TG13.1 – Roof Park Landscaping and Irrigation

Questions are numbered in the order received. Numbers missing in the sequence either have been answered in a previous response set or will be answered in a future set.

TG 13.1-010

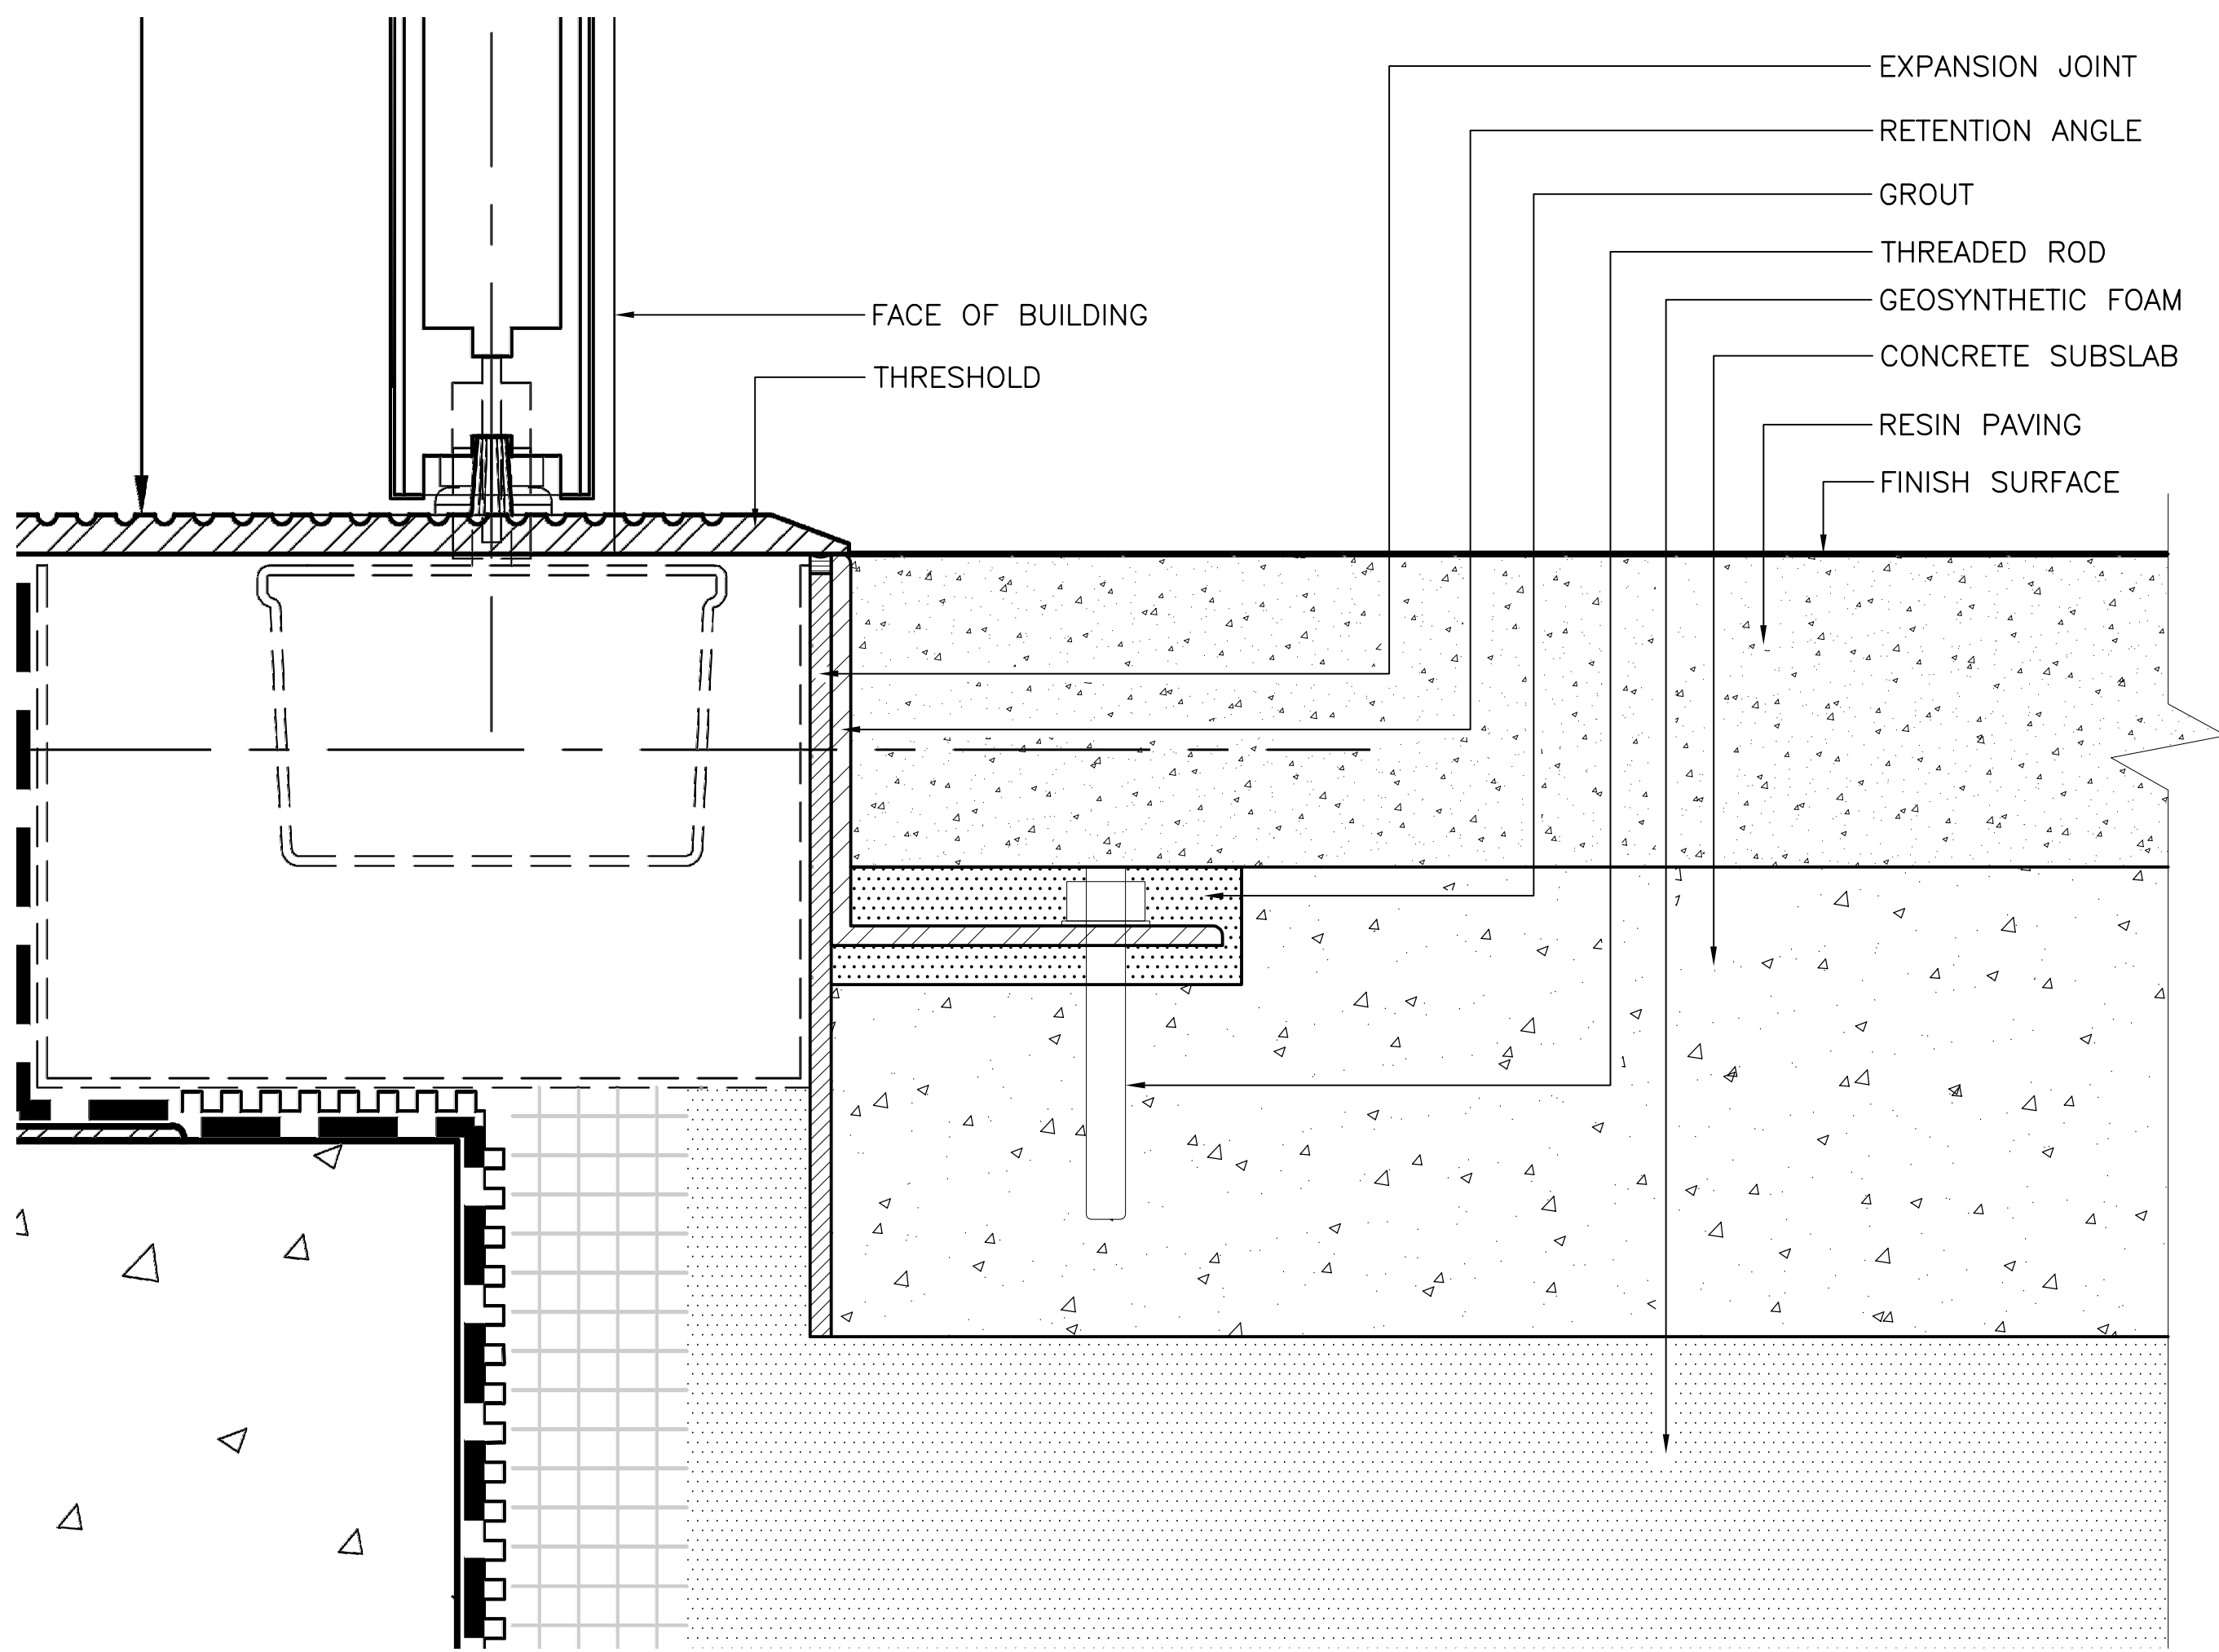
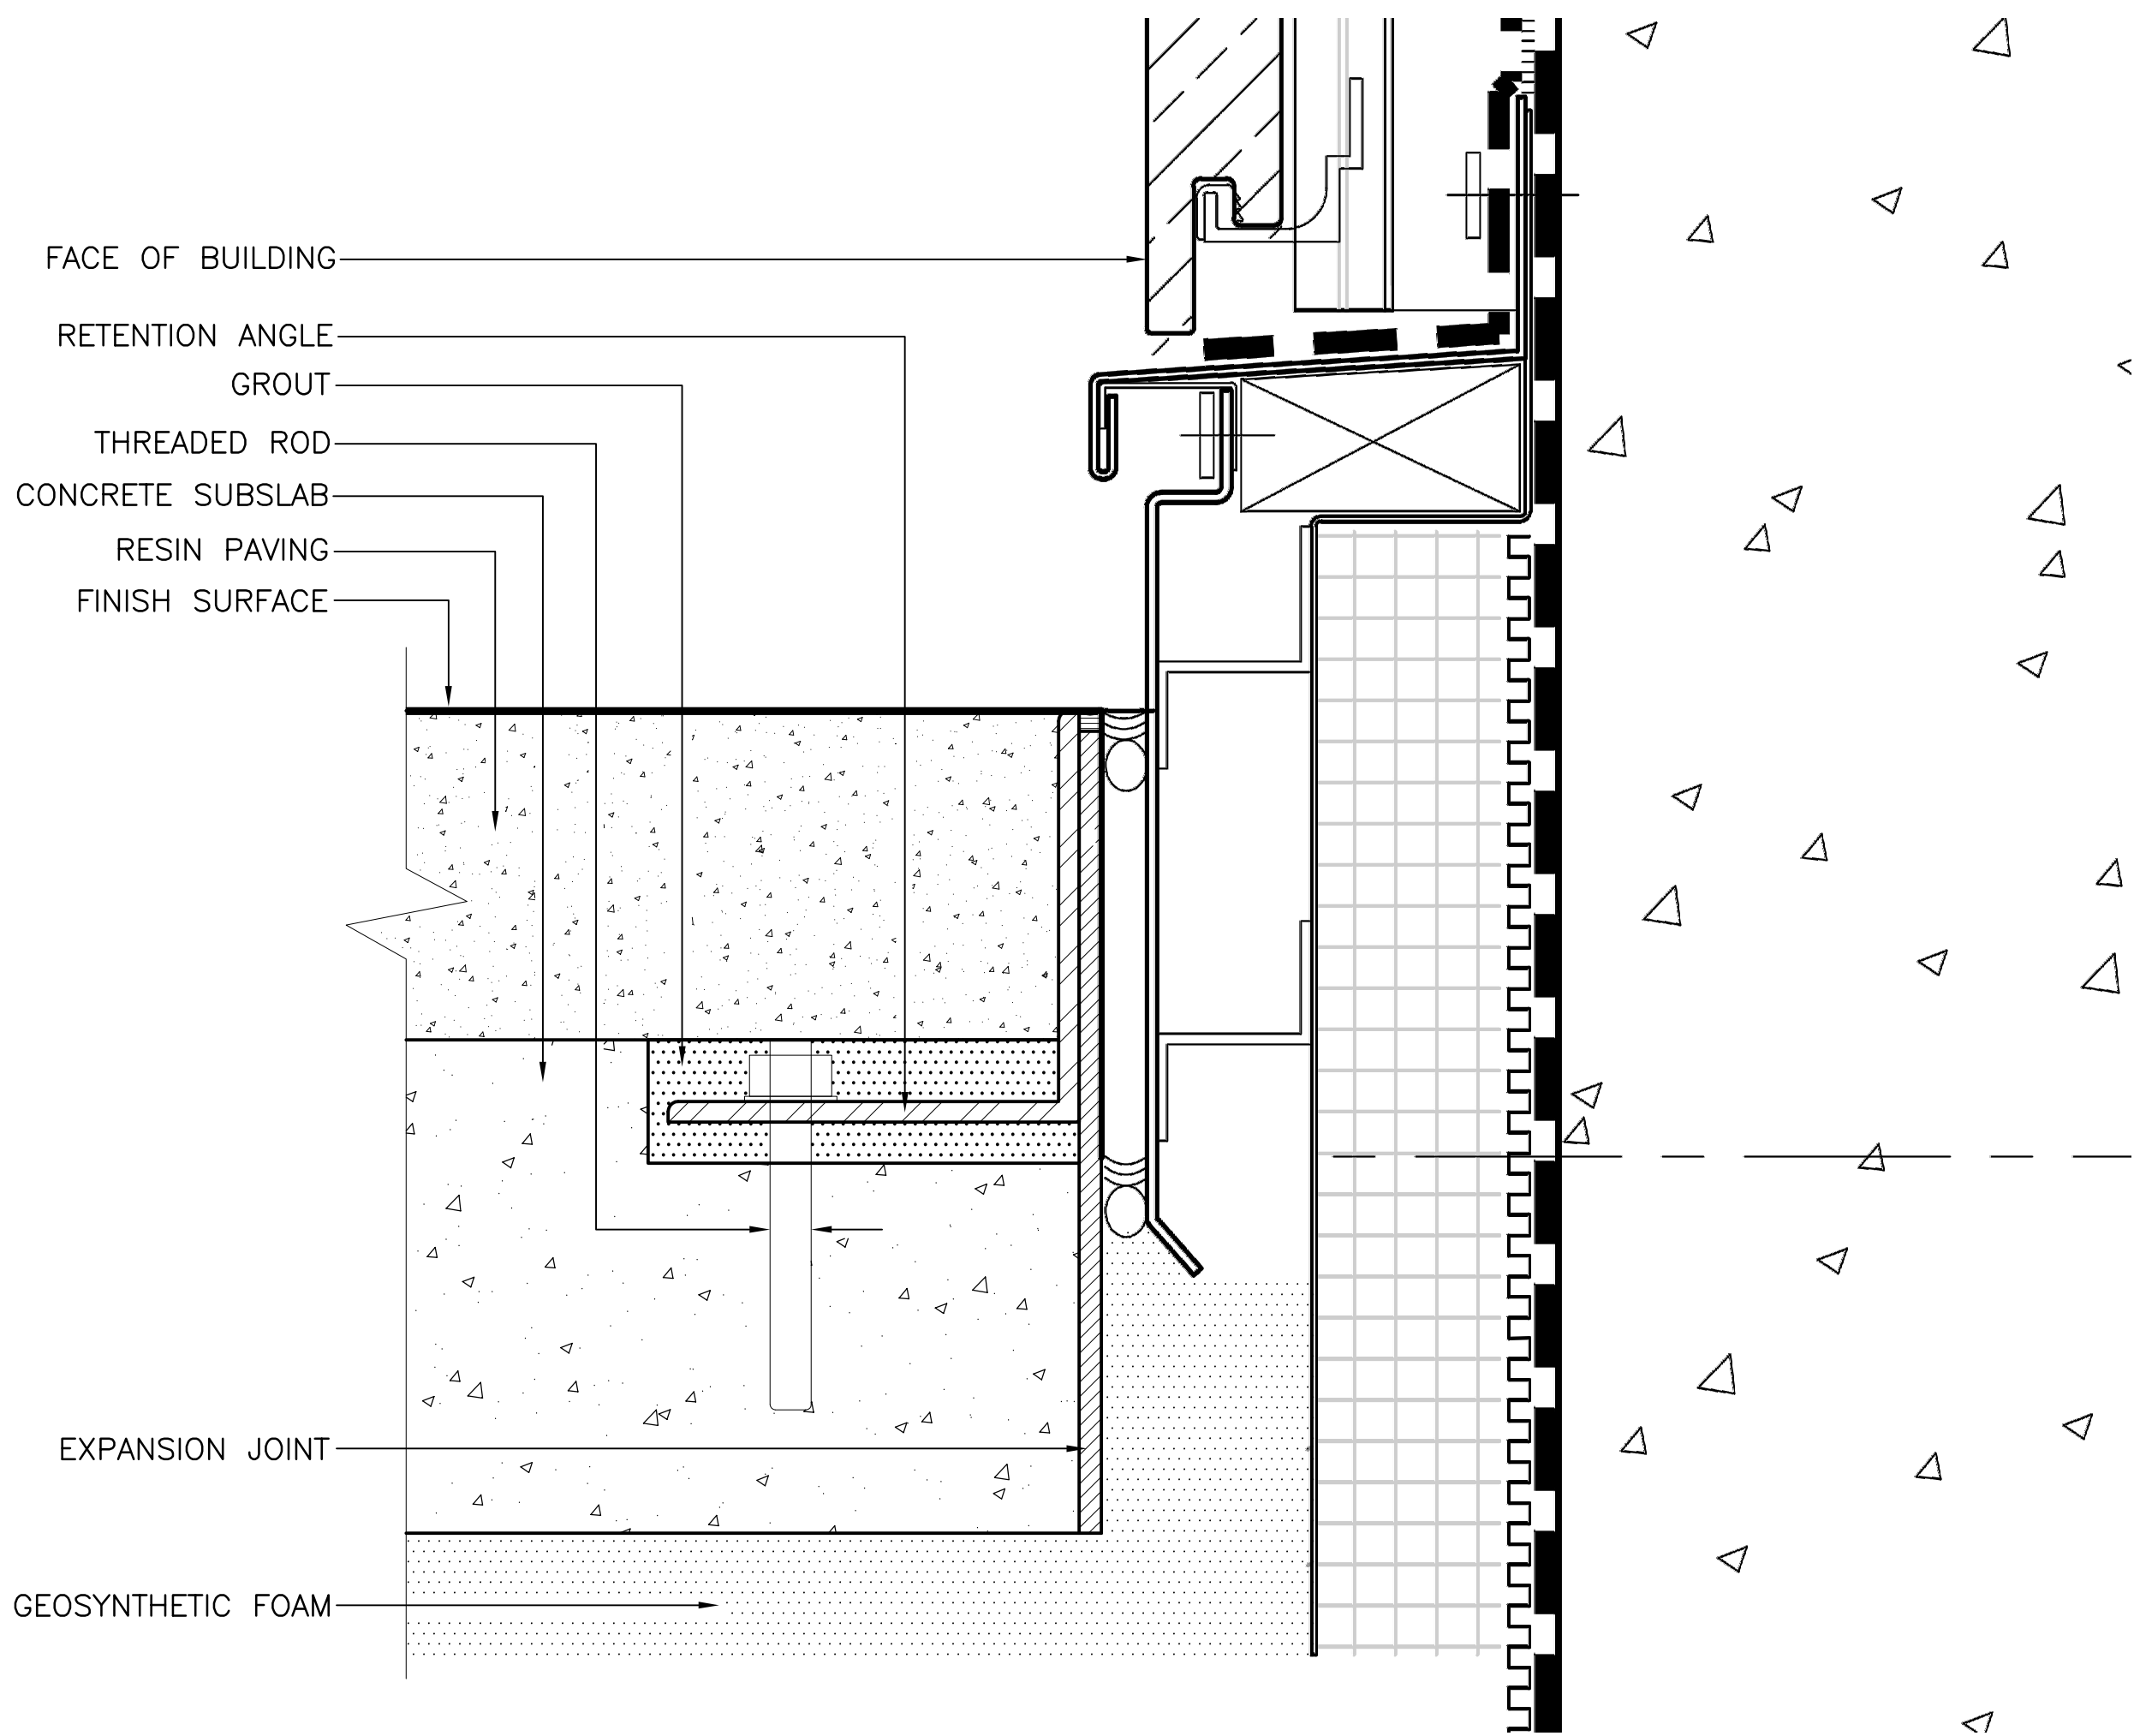
TG13.1-010	3/25/2015	1/L1-2642, 1/L1-9601, 3/A1-8911		Clarify if the resin paving at the restaurant deck is able to push directly up to the restaurant or if retention angle is required. There is no retention angle shown in 1/L1-2642, 1/L1-9601, or 3/A1-8911. If retention angle is required, please provide updated details.	Retention angles are required at the restaurant deck resin paving area. Please refer to the attached SKLA 378-3 and 378-4 for details.
TG13.1-011	3/25/2015	L1-7670, L1-7671, L1-7672		Do utility vaults need to be mechanically fastened to the topping slab? If so, provide details for this connection.	No. Utility vaults do not need to be mechanically fastened to the topping slab.
TG13.1-012	3/25/2015	L1-4602		The invert Dimension at GL 1 / G shows a value of 843.42. This appears to be a typo. Please provide the correct invert dimension.	Please refer to the attached SKLA 382.1 to see the updated invert elevation at GL 1/G.

RESIN PAVING AT RESTAURANT DECK THRESHOLD

RESIN PAVING AT RESTAURANT DECK BUILDING FACE
